Historic Landmarks and Preservation Districts Commission

Report to the Committee

Case No: 18COA1115
Classification: Committee Review

Property Address: 608, 610, 612, 614, 616 W. Breckinridge Street

Figure 1. The 2/2 double hung vinyl window that was turned on its side and installed as a sliding window.

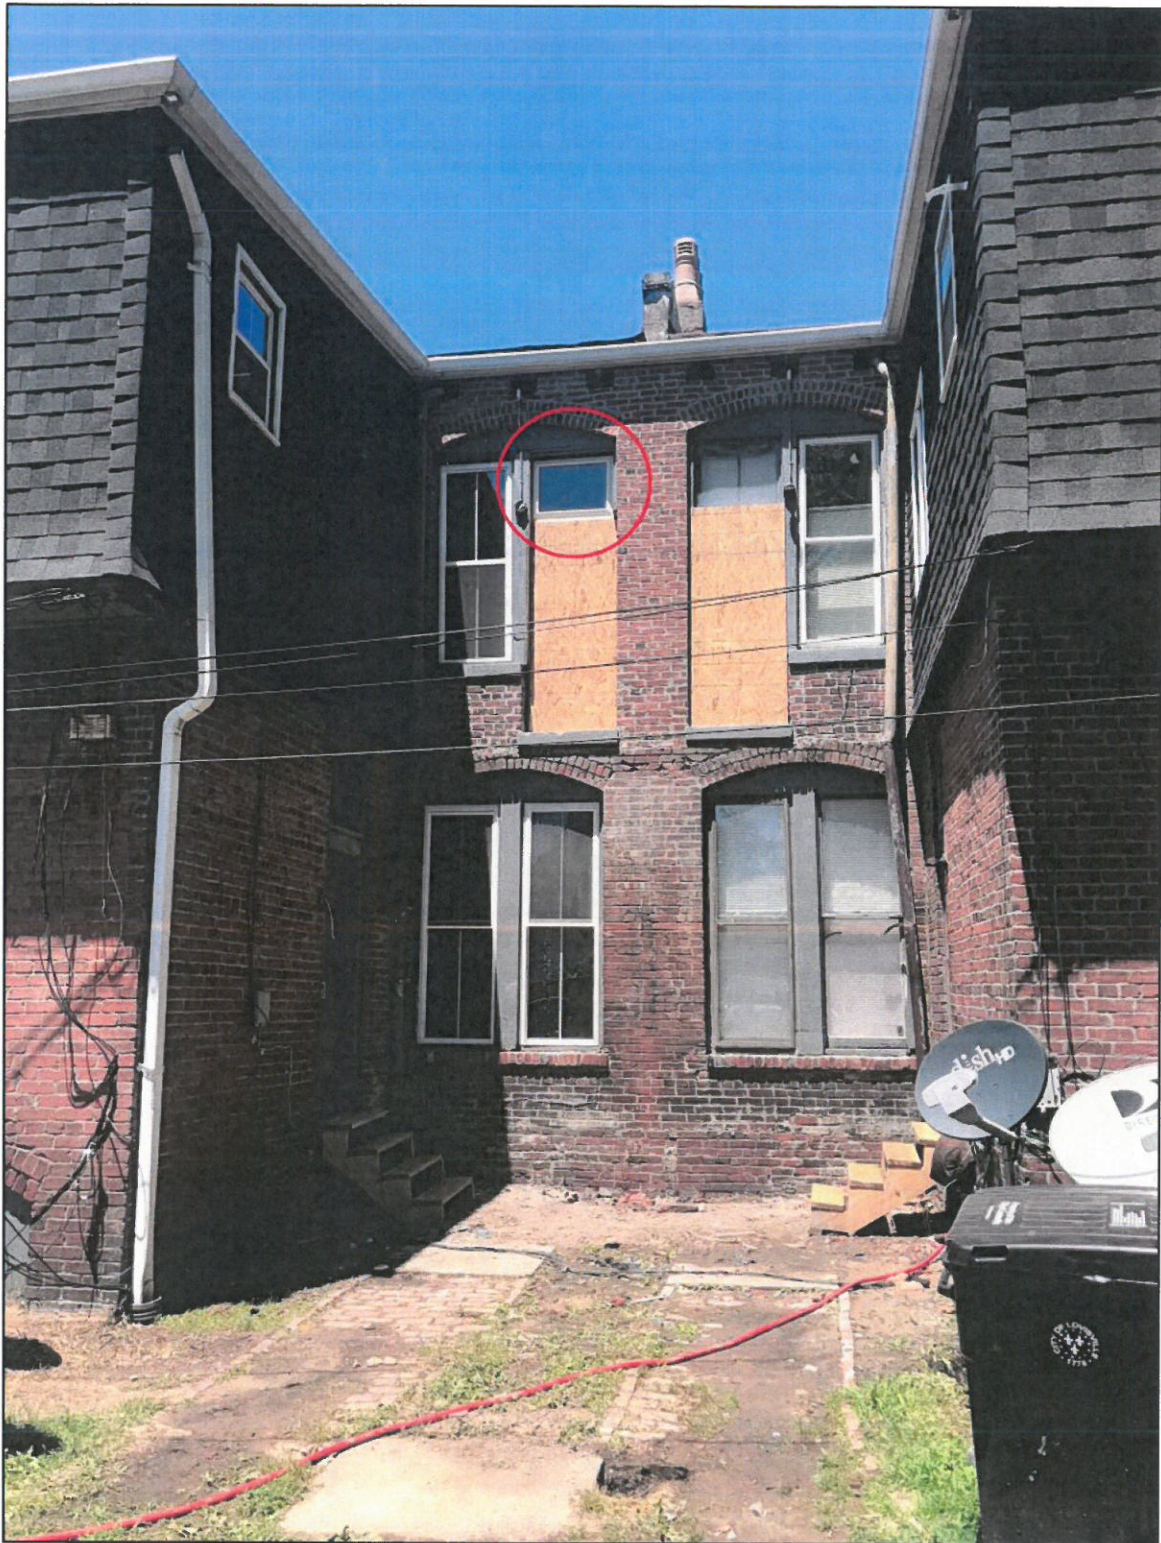
Sides and rear elevation windows: The proposed sides and rear elevation window replacement generally meets the Limerick Design Guidelines for **Window**. Even though most of the replacement occurred before the window conditions could be assessed, the replacement windows mimic the historic 2/2 double hung windows and fit the historic window openings. However, there is one replacement window on the east elevation of the rear that staff recommends replacement. It appears that one 2/2 double hung vinyl window was turned on its side and installed as a sliding window (**Figure 1**). This is not appropriate as it

does not meet the design guidelines with its horizontal muntins. The window should be replaced with a new sliding window with no muntins. Some of the rear window concrete and/or limestone sills had been replaced with brick window sills. Staff recommends that the remaining concrete and/or limestone sills on the rear elevation be preserved. They should not be replaced with brick sills as this is not an appropriate sill treatment on a historic structure.

Figure 4. The new 2/2 double hung vinyl windows over 608 W. Breckinridge Street.

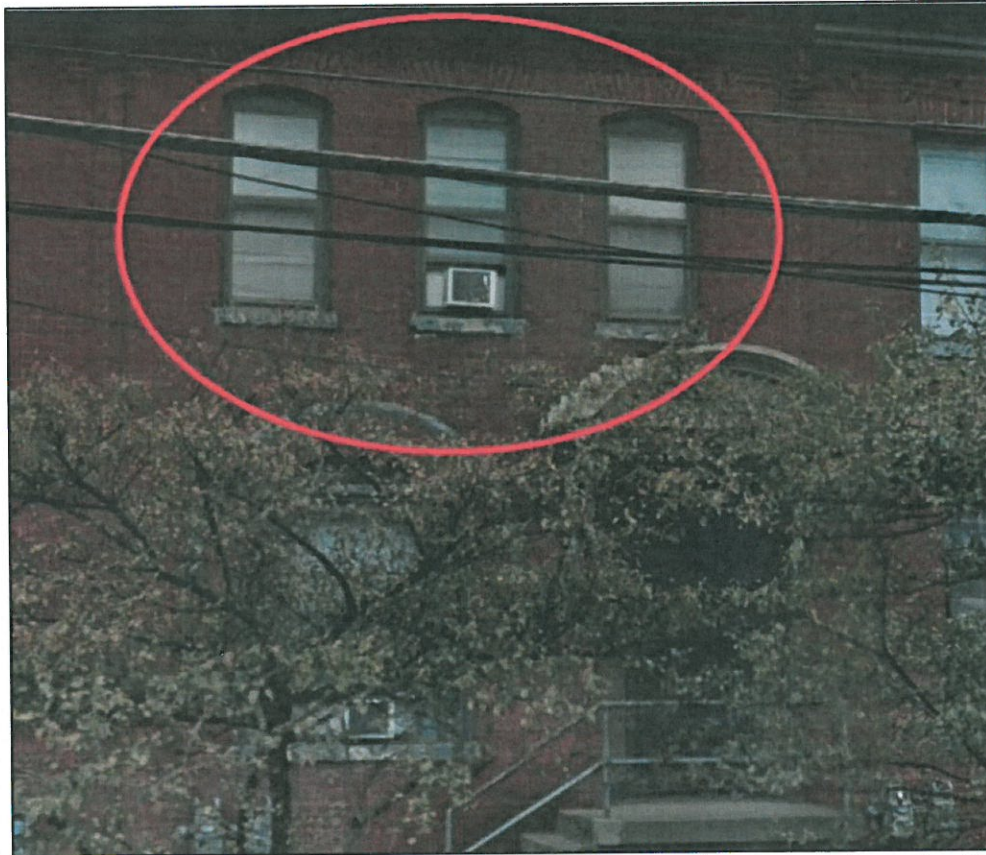
Front façade windows: See **Figure 3** for a key of the windows discussed below. The windows that were replaced prior to the stop work order include numbers 1, 2, 3, 4, 9, 10, 11, 12, 15, and 16. The proposed front façade window replacement does not meet the Limerick Design Guidelines for **Window**. The historic windows on the front façade were a mix of rectangular and arched double hung windows. All of the windows were 1/1 meaning they had no muntins. Historically, solid sheets of glass for 1/1 windows were more expensive than the smaller panes for multi-pane windows, which is why 1/1 windows were located on the front façade and multi-pane windows were located on the side and rear elevations. The replacement windows on the front façade are all 2/2 double hung vinyl windows, which do not match the historic windows or meet Guideline W2 or W6. The replacement windows are somewhat tinted and reflective, which does not meet Guideline W10. The second story replacement windows over 608 W. Breckinridge Street (Windows 1 and 2) do not fit the arched window openings creating large gaps (**Figure 4**). Furthermore, the wood that filled the segmented arched windows over 612 W. Breckinridge Street (Windows 9, 10, and 11) allowed a rectangular window to fit under an arched opening, but that wood was removed and a vinyl window was inserted that does not fit (**Figure 5** and **Figure 6**). These fit issues do not meet Guideline W4.
